**CCB 7631**

**Pre and Post Change Summary**  
**PCN #: NTDO-03NACN832**

# Lead Frame Comparison

## CARC

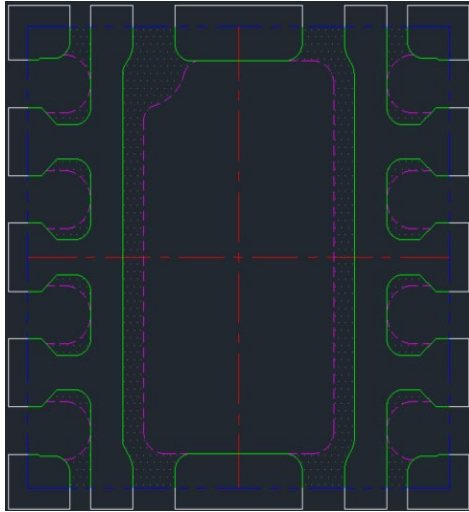
<b>Paddle Size</b>	43x67mils
<b>DAP Surface Prep</b>	Ag spot

## ATP7

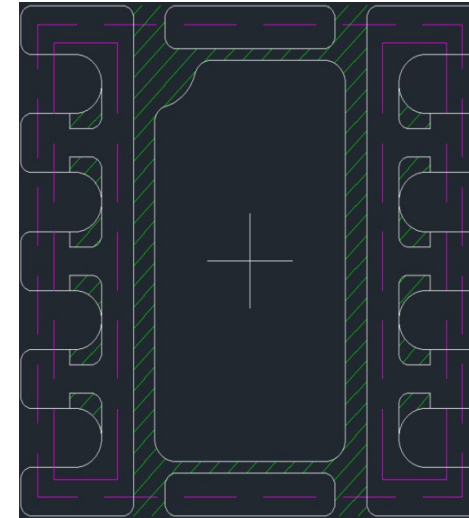
<b>Paddle Size</b>	43x71mils
<b>DAP Surface Prep</b>	Ring Ag
